**Wuskwatim Generation and
Transmission Projects**

Responses to Technical Advisory Committee

August 8, 2003

**re: SUPPLEMENTAL EIS FILING:
WUSKWATIM GENERATION and TRANSMISSION PROJECTS**

Figure 2
DFO-S-39: Southern Indian Lake Water Levels

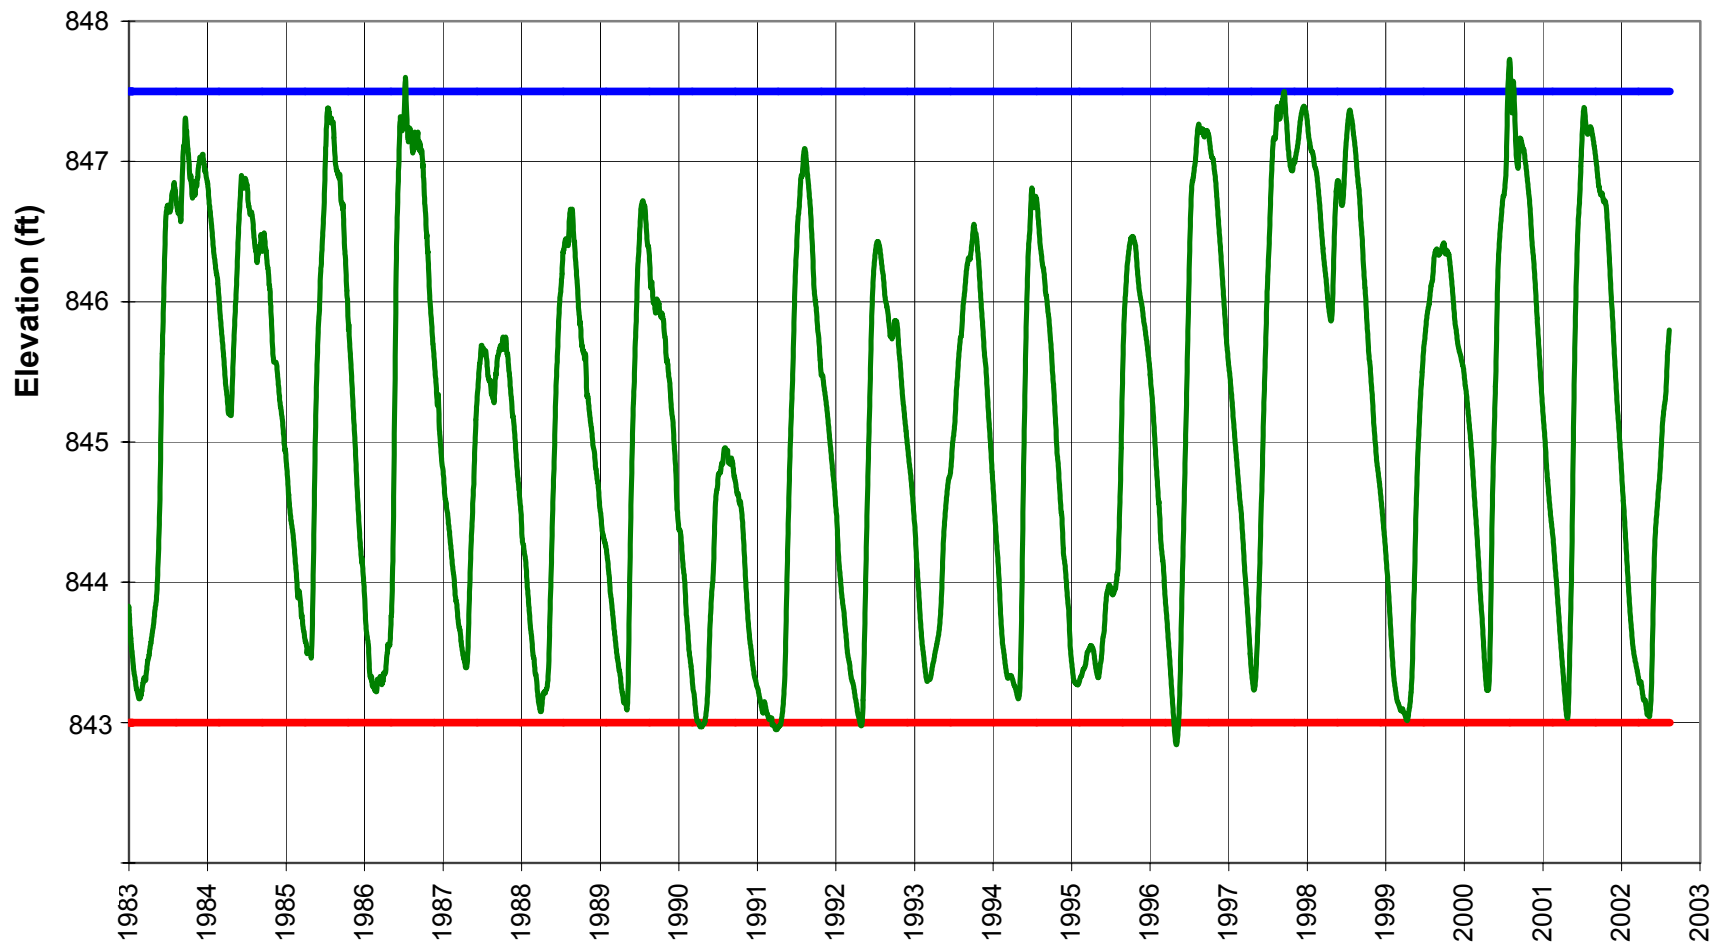
Comnt. No.	Page (DFO no. or Para.)	Nature of Comments			Response from Manitoba Hydro and Nisichawayasihk Cree Nation (NCN)
		EIS Section	Issue	Summary of Comments	
DFO-S-39	10 (54)	Vol. 3	Need for information on fish habitat impacts, monitoring and reporting re: changes to operation of the northern hydroelectric system	<p>"Information provided at the "Needs and Alternatives" Technical Workshop (July 09, 2003) indicated that the "Wuskwatim Project would not change CRD operation and will not change flow patterns except for daily flow shaping in local area of Wuskwatim" but that "with the Project there may be a small effect on Lake Winnipeg Regulation" depending on the nature of the use of energy generated by the Project.</p> <p>a) Please indicate if the changes in system operation (under maximum potential change circumstances) could potentially impact fish habitat.</p> <p>b) Indicate how monitoring and reporting on system changes that could potentially affect fish habitat will be undertaken and reported."</p>	<p>The response to this question is provided in two parts. Part A is attached as Appendix B-DFO-S-39 and provides a conceptual explanation of the Hydro System operation and the role of the proposed Wuskwatim Generating Station, including possible effects on system operations. Part B follows below and draws on the information provided in the appendix.</p> <p>B) Cross Lake, which is immediately downstream from Jenpeg, is used as an indicator of the effects of LWR operational changes on fish habitat.</p> <p>Part A states that if Wuskwatim energy is used for domestic purposes or for firm export sales "that the summer elevation of Cross Lake is expected to decrease by an average of 0.04 feet with a maximum decrease of 0.11 feet" and that the "average winter elevation is expected to increase by 0.04 feet with a maximum increase of 0.12 feet". It also indicates that "these changes are so small that they will not be perceptible relative to the many other factors that affect outflows from Lake Winnipeg".</p> <p>Effects on fish and fish habitat from water level changes of the above stated magnitude are expected to be neither significant nor measurable with a "well designed sampling program". Over-wintering capacity may be slightly increased in the winter and feeding and rearing habitat may be marginally decreased in the summer but it is expected that neither (even under maximum conditions) would be of sufficient magnitude to measurably affect fish populations either positively or negatively. Effects would be completely masked by other factors such as normal changes in water supply (8 feet), wave up-rush (4 feet), ice staging (0.8 feet), and wind set up (0.5 feet).</p> <p>Part A also indicates that if Wuskwatim energy is used for non-firm export sales "that the summer elevation of Cross Lake is expected to increase by an average of 0.12 feet with a maximum increase of 0.34 feet" and that the "average winter elevation is expected to decrease by 0.08 feet with a maximum decrease of 0.20 feet". with "no perceptible change in elevation in both the upper and lower quartiles". Although the changes are marginally higher than for firm export sales, they remain small and the effects on fish and fish habitat (even under maximum conditions) are expected to be neither significant nor measurable with a "well designed sampling program". Feeding and rearing habitat may be marginally increased in the summer and over-wintering capacity may be slightly reduced in the winter (during average flow periods) but neither would be of sufficient magnitude to measurably affect fish populations either positively or negatively.</p> <p>Manitoba Hydro routinely collects detailed information on water levels and flows throughout its operating system. The information will be made available upon request.</p>

The annual pattern of filling and drawdown of Southern Indian Lake within its licence constraints for the period since 1983 is shown in Figure 2. It is noted that for some periods the typical pattern of filling and drawdown does not occur because of either a shortage of water available to CRD or because the Lower Nelson River generating plants already have sufficient water supply due to flood flows being released from Lake Winnipeg.
